DELEGATED APPLICATION REPORT

App Ref: PL/25/1074 Full planning permission

Address: 147 Upper Woodcote Road, Caversham, Reading, RG4 7JR

Proposal: Erection of replacement dwelling (amended)

Block Plan

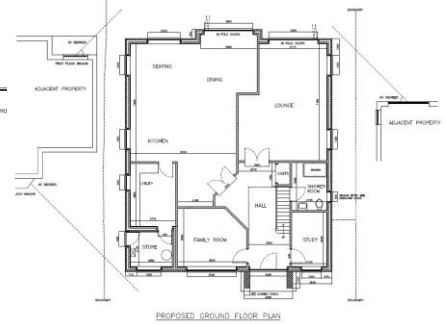
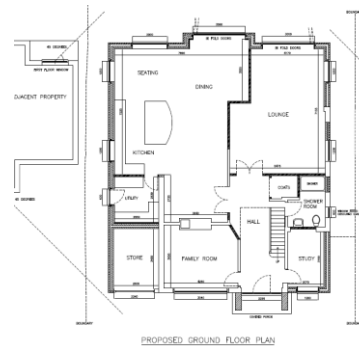
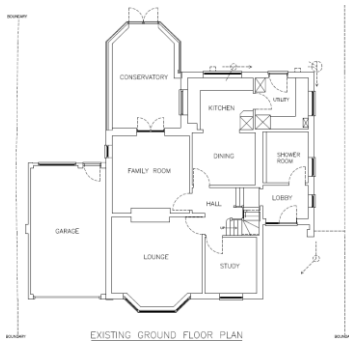
RBC Transport – The following are the original comments dated 15/9/25 based on the original block plan, which did not include the revised centralised access and bin and cycle storage to the front:

A bin storage area has been illustrated at the rear of the site, it is assumed that the bins will be moved to the property boundary for collection. Residents are expected to present the bins at the boundary of the property/public highway on collection day and the bins returned to the property after collection.

With reference to the Block Plan (undated), Drawing No. WR.009, I note the proposed bin store is in close proximity to the trees, the bin store has not been mentioned within the AIA. It is a requirement that all trees within 15m of any part of the proposal are considered and protected from harm. The drawings used in the TPP and TCP are not of the block plan which is why this has not been considered. However, it is still required as the bin storage would appear to be in direct conflict with G1 Yew trees and thus the AIA requires amendment to provide further clarity on this.

Planning Officer Note: Further to the submission of an amended block plan with the revised access and location of bin and cycle storage to the front, and the submission of a CMS, Transport confirmed that the proposal was acceptable subject to conditions, but did recommend that cycle storage would be better to the rear for added security, but that the proposed provision was deemed acceptable.

Proposed Landscaping scheme

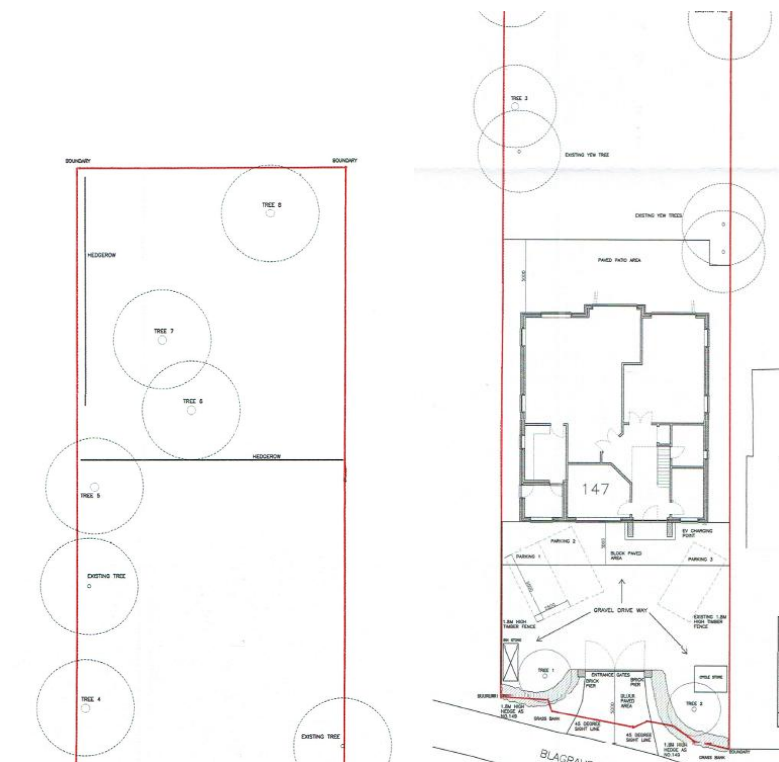
The existing vegetation and proposed landscaping have not been shown on any of the plans, making it difficult to assess the proposal's impact on the landscaping. A landscape principles plan would help us understand any changes. I cannot currently assess any changes to the driveway (I note a grassed area in the centre that hasn't been shown on the plans) and the associated impact on the street scene.

I also expect that there would be changes to the landscaping in the rear garden, given that a new dwelling is proposed and would appear to be built on existing hard surfacing, this should be demonstrated and considered. To the rear of the site is an Area of Outstanding Natural Beauty and thus landscaping should be considered to ensure it does not detract from the character, such as including excessive amounts of hard surfacing. It is also expected that where developments are of an increased size and there is a loss of soft landscaping that efforts to mitigate this impact are demonstrated, which has not been shown. The site is within an AQMA and has a large rear garden which could host an opportunity for tree planting.

Planning Officer Note: There was further dialogue between officers and the applicant and subsequently a landscaping scheme was presented to include new trees in the rear garden and an amended layout to the front including trees and hedgerow with a single centralised point of access and bin and cycle storage to the front. To avoid a pre-commencement condition, a detailed landscaping plan with accompanying plant schedule was submitted, which the Natural Environment Officer confirmed was acceptable. This is referenced in the assessment below.

The amended scheme includes 8 new native trees of suitable stock size, including within the front and rear gardens along with further hedgerows. Details of the planting schedule and maintenance arrangements have been submitted to avoid the requirement for pre-commencement conditions. The Natural Environment Team confirmed the acceptability of the landscaping scheme, and it is considered to adequately meet the policy requirements of Policies EN12 and EN14 subject to conditions to accord with the landscaping plan and works to be in accordance with the protective measures within the Arboricultural Impact Assessment.
